## DEVELOPMENT APPLICATION ASSESSMENT REPORT

<b>Application Number:</b>	DA2021/2639
----------------------------	-------------

<b>Responsible Officer:</b>	Olivia Ramage
<b>Land to be developed (Address):</b>	Lot 52 DP 7593, 25 Alleyne Avenue NORTH NARRABEEN NSW 2101
<b>Proposed Development:</b>	Demolition works and construction of a dwelling house including a secondary dwelling and swimming pool
<b>Zoning:</b>	C4 Environmental Living
<b>Development Permissible:</b>	Yes
<b>Existing Use Rights:</b>	No
<b>Consent Authority:</b>	Northern Beaches Council
<b>Land and Environment Court Action:</b>	No
<b>Owner:</b>	Troy Carter
<b>Applicant:</b>	Daniel John Raymond

**Figure 1 - Eastern Envelope Breach**

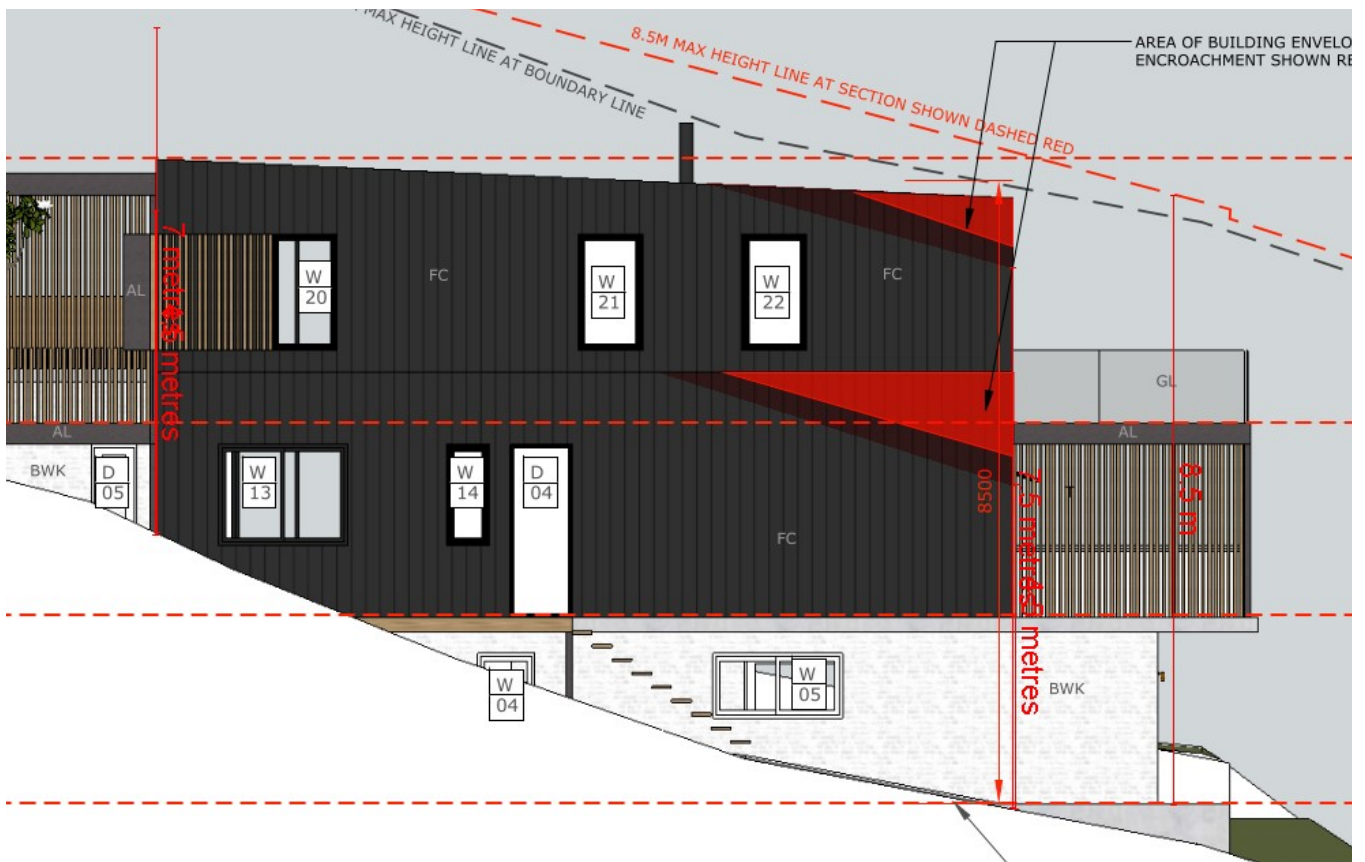
On the eastern elevation there are two encroachments of nil-0.9m and nil-1.58m for a length of 3.5m and 4.8m respectively.

**Figure 2 - Western Envelope Breach**

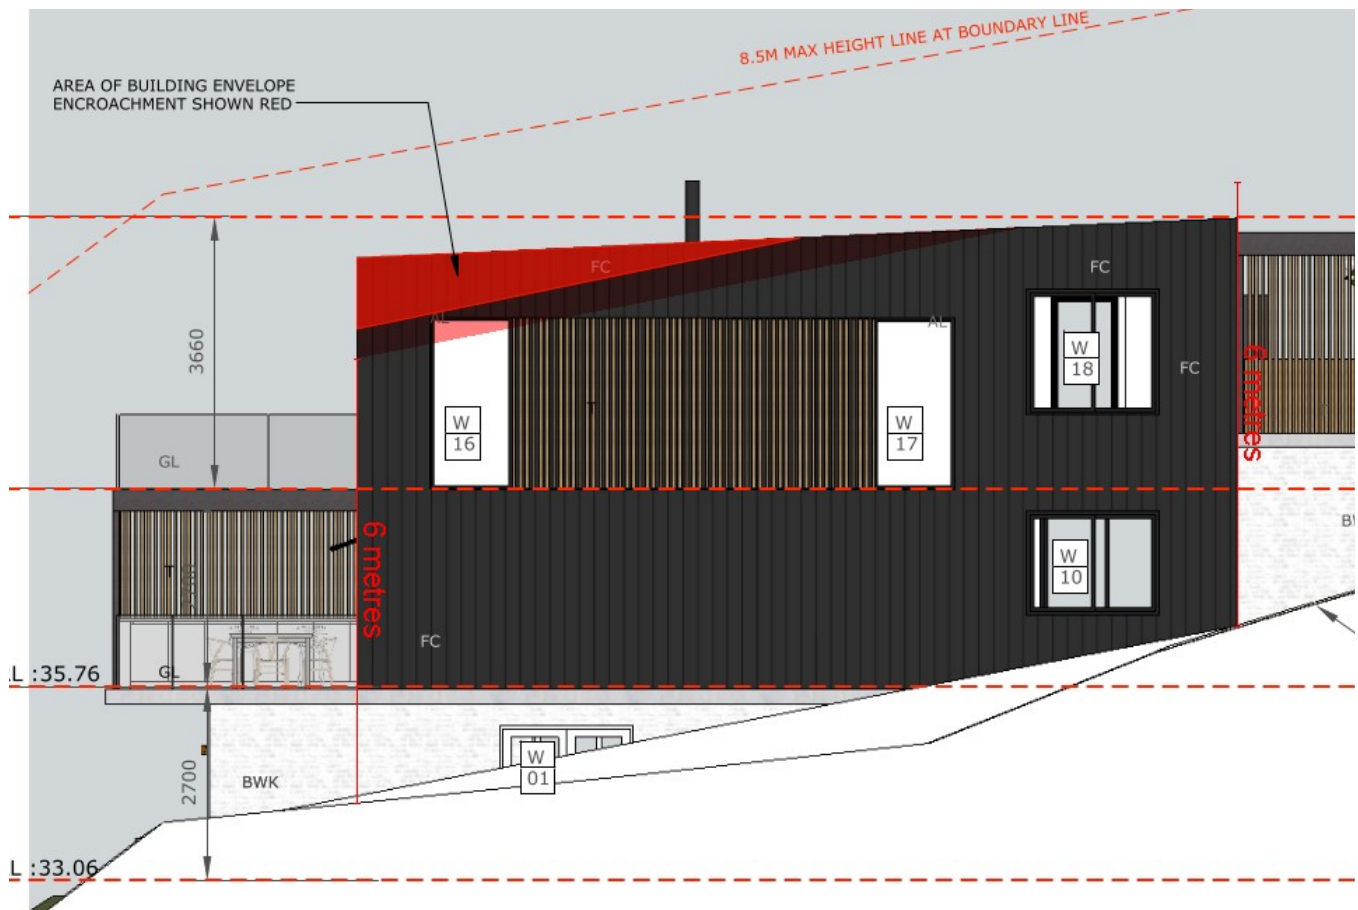
On the western elevation there is an an encroachment of nil-1.39m for a length of 6.9m.
